INDESIT company

LBE8X

F026969

Technical Documentation guidelines

Fig. 1

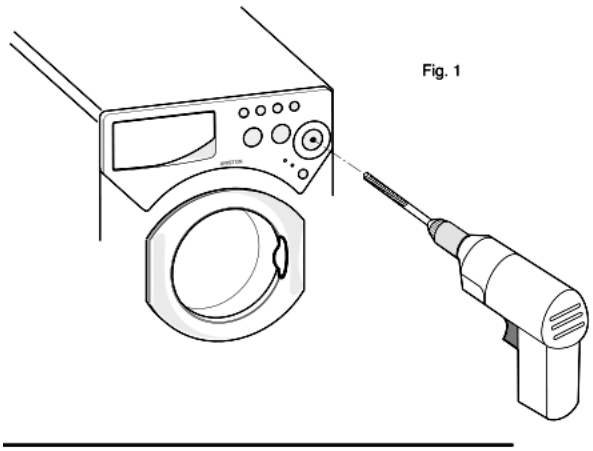
n1040241: Indivisible timer knob and push-push mec

From serial number 20305.0001, the component knob / selector code 084812 is provided with internal flaps, which ensure a perfect assembly of the knob and push-push mechanism on the built-in washing machines. This prevents the knob from coming off when the plastic material becomes soft due to temperature increasing inside the appliance during the drying phase.

To remove the selector knob, proceed exclusively as follows:
1) Using a drill with a 12 mm bit, drill a hole in the centre of the knob (see fig. 1).
2) Using a cross screwdriver, loosen the screw that secures the knob to the selector (see fig. 2);
3) Extract the knob with push-push mechanism from the selector (see fig.2) .

Fit the new knob after fixing with the screw the push-push mechanism (recovered) to the selector shaft.
In the event that the old push-push mechanism cannot be reused, use the kit code 087814 that comprises the following items:

Code 084816 - Push-push mechanism;
Code 087815 - Timer screw 1/2 T4,2X12.7;
Code 047922 - Compression spring;
Code 084812 - Component knob / timer.

FIG. 1

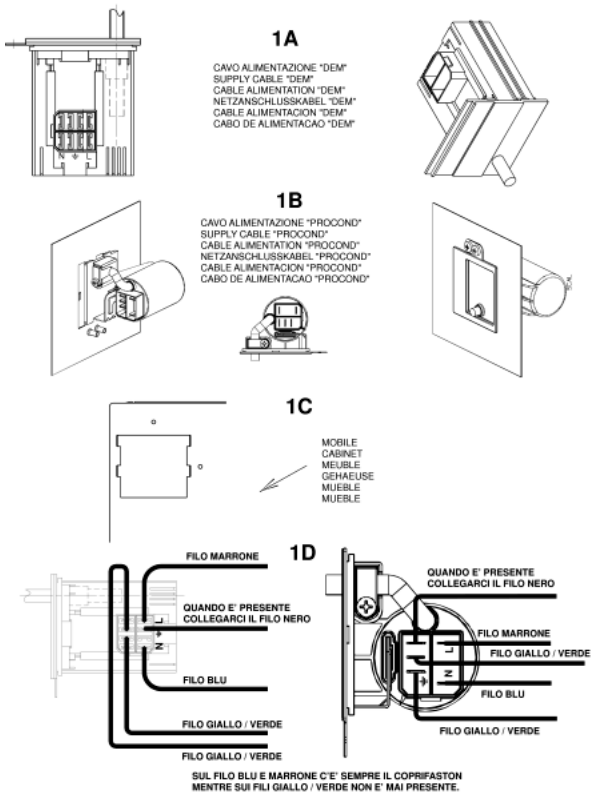
n1040276: Power supply cable + integrally moulded filter.

All appliances produced in the Comunanza (from serial no. 21008.0001), Teverola (from serial no. 21111.0001) and Brembate (from serial no. 21119.0001) factories have been equipped with power supply cables with integrally moulded filter (see fig.1 - 1A and 1B) and new units having a specific opening at the back for fixing the new cables (see fig. 1 - 1C).
The new units, together with the new cables, can be used in place of the premodification ones, by connecting the wiring to the cable, as shown in figure 1 - 1D.
The codes of the new units and of those replaced (ESI - table n1040276fig02), which will be managed until stocks run out, are given below.

IMPORTANT: the fixing / continuity screw is a specific self-scraping screw (code 092348) that ensures earth continuity between the filter and the unit. The same screw must be refitted in order to guarantee machine conformity.

The premodification wirings, are also managed for modified products by making the connection to the terminal block of the new cable as shown in fig. 1 - 1D.
The wiring diagrams given in the Documentation remain unchanged.

The new power supply cables are:
Code 091632 - Power supply cable 3x1 schuko 1.5m+capacitance filter;
Code 091633 - Power supply cable 3x1 schuko 1.5m+inductive filter;
Code 091634 - Power supply cable UK 3x1 l= 1950mm + inductive filter;
Code 091635 - Power supply cable UK 3x1 l=1950mm+capacitance filter;
Code 091636 - Power supply cable l=2.55m AUS+inductive filter;
Code 091641 - Power supply cable l=2550mm AG +capacitance filter;
Code 091642 - Power supply cable 1.85mt SHUKO no inductive filter;
Code 091643 - Power supply cable 3x1 (CH) 1.5m+inductive filter;
Code 091645 - Power supply cable 3450mm SOUTH AF.+capacitance filter;
Code 091690 - Power supply cable shuko l2.55m KOREA+inductive filter;
Code 091689 - Power Supply cable l=2550mm AG+inductive filter.

n1040282: New drainage OKO system.

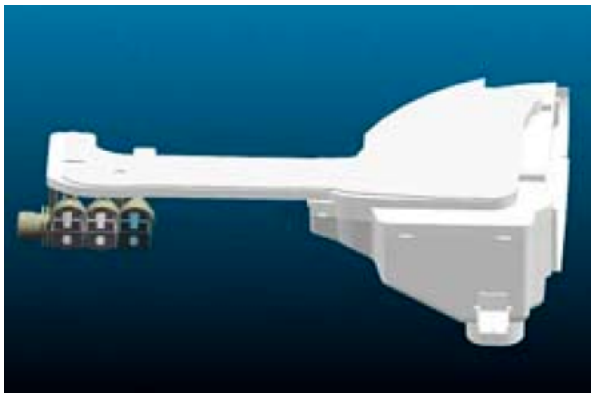
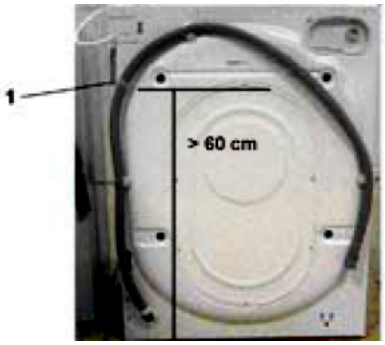
From serial number 21219.0001, the new "OKO" drainage system has been introduced on the washing machines produced in the Comunanza factory.

- EEPROM (the OKO system requires a new setting of load timing parameters). THE NEW EEPROMS REPLACE ALL THE ONES CODED PREVIOUSLY.
- BOWL (hopper tube hole shifted forwards);
- DETERGENT LOADING TUBE (see fig. 1);
- PRESSURE SWITCH (changed levels);
- OKO PUMP BOWL BLOWER + BALL (see fig. 2A, 2B and 2C);
- CONDUCTIVITY SENSOR (if provided, it is shorter than the premodification item);
- DRAIN PUMP (without detergent collecting tube connection);
- HOPPER (shifted in front of detergent loading tube connection). Fig. 3A post-modification. Fig. 3B premodification);
- AIR TRAP (different shape);
- PRESSURE SWITCH TUBE (different length);
- DRAIN TUBE STOP (specific);

In particular, the OKO system consists of a spherical plastic component inserted in the tube that connects the bowl to the drain pump (see fig.2 A).
At the beginning of each wash cycle the washing machine fills water for 10 seconds and activates the drain pump for 2 seconds. In this way, the water level in the bowl is different from that in the drain tube; this difference increases the thrust of the ball upwards, closing the bowl-pump connection tube hermetically (see fig. 2D).
This system has the double advantage of:

1) separating the wash water and the water in the drain hose, thus saving energy during the heating phase;
2) and ensuring optimal use of all the detergent.
With the introduction of this new component, the detergent collecting tube is no longer required and the pump has one hole only to convey water from the tank.
For the correct operation of the OKO system, it is important that the drain hose of the washing machine remains fixed to the back of the unit with a plastic clamp (to this end, the clamp withstands a 25 kg load; see reference 1 in fig. 4); otherwise, the drain hose must absolutely reach the height of the clamp. (minimum 60 cm.)

n1040325: New shock absorber fixing system with pin

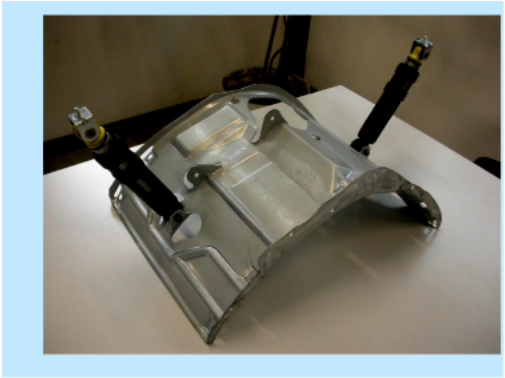
From serial no. 40427.0001, shock absorbers have been fixed to the tank unit cradle with two 11 mm pins code C00110163 (see fig. 01 and 02 enclosed) in place of the 8 mm screws code 093750 and relevant locking nuts code 030443, on all washing machines and dryers produced in the Comunanza factory.
The items affected by this modification are:

1) The cradles have the same Service code, as they can be used in place of the new ones after widening the shock absorber fixing holes to a diameter of 10 mm.
Code 093848 - Tank unit cradle 46 lt
Code 093878 - Tank unit cradle 40 lt.

2) The new shock absorbers, with fixing bushing having no s/steel spacer, are not managed as they are interchangeable with the premodified items (make sure they are CIMA type, as the managed items), fixed with M8 screws code 093750 and related locking nut code 030443 (see figs. 05 and 06).
Code 093884 - Shock absorber 80 N
Code 093885 - Shock absorber 100 N

To remove the shock absorber from the tank, first extract the pin with a few hammer taps (see fig.03) until it is aligned with the tank bracket and then pull it out with a pair of pliers (see fig. 04).
(To refit the shock absorber use a new pin. Insert the pin until the toroidal edge is aligned with the bracket.)

Fig . 001

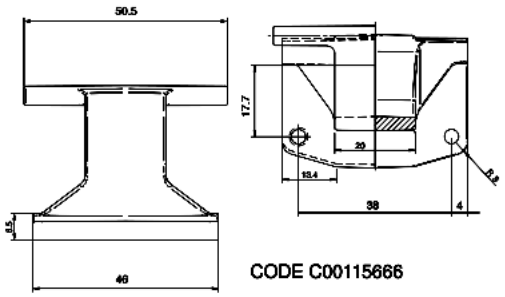
n1040349: Introduction of 150° Zamac hinge on Ariston 46 models.

From serial no. 50207.0001, all Ariston models produced in the Teverola factory (see table 001 attached) with industrial code (given on the rating plate) starting with 46, have been equipped with a Zamac hinge with 150° opening angle, code C00115666

(see Fig.001).
This modification has involved the introduction of the following items:

Code C00115670 - Complete door EVOII 150° white 27 with standard glass;
Code C00115674 - Complete door EVOII 150° white 27 with long glass;
Code C00115667 - EVOII body for 150° hinge white 27;

The premodified items are not interchangeable separately with the modified ones.
